TITLE: PUBLIC HEARING regarding a Board Approval of the Meadowlark Airpark Bar Barndominium Site Plan, located in Tract 11, Meadowlark Airpark, Laramie County, WY.

PZ-23-00073-Meadowlark Bar Barndominium
Site Plan: New and Major Amendments
Agency Review #1

RE: Meadowlark Bar Barndominium Site Plan (PZ-23-00073)

SITE PLAN & LANDSCAPE PLAN
MEADOWLARK AIRPARK
BEING SITUATED IN SECTION 6, TOWNSHIP 14 NORTH, RANGE 64 WEST OF THE SOUTH 6TH PRINCIPAL MERIDIAN, LARAMIE COUNTY, WYOMING
PREPARED MAY 2023

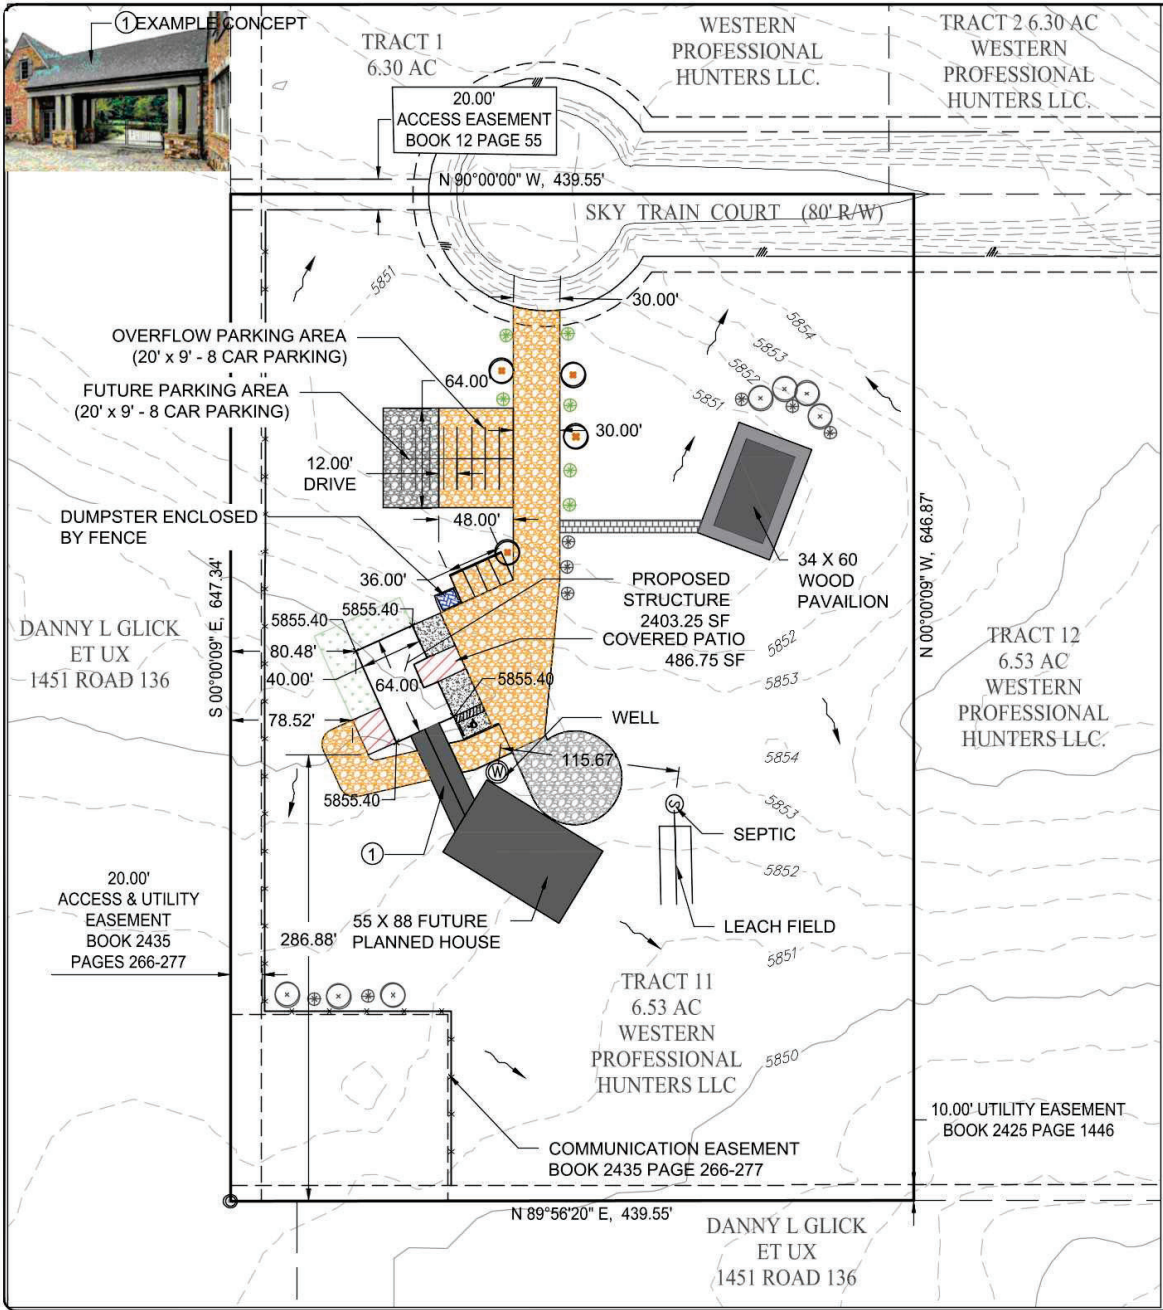
1. I concur with the request for a waiver of a detailed Drainage Study and Traffic Study since this development will have negligible impact on both.
2. Per the LCLUR, the minimum driveway and approach is 30' and the site plan drawing shows it at only 20'.

3. Are there enough parking spaces being provided with only 3? The project narrative indicates there will be 2 employees (which will utilize 2 parking spaces) and that only leaves one parking space and one handicapped space. The narrative indicates an occupancy of 19 people. Even if you assume 4 people per vehicle, that indicates 5 vehicles and then you add the 2 employee's vehicles and that is a total of 7 spaces needed. Generally, you would assume 1.5 - 2 people per vehicle which would take you up to 12 - 15 spaces needed for patrons and employees.

Corrected on the revised site plan.

The two employees will be parking in the garage as they are the owners of the property. We have added one more striped parking space for a total of 4 plus the ADA space, as well as a designated overflow parking area that can accommodate up to 8 additional vehicles.
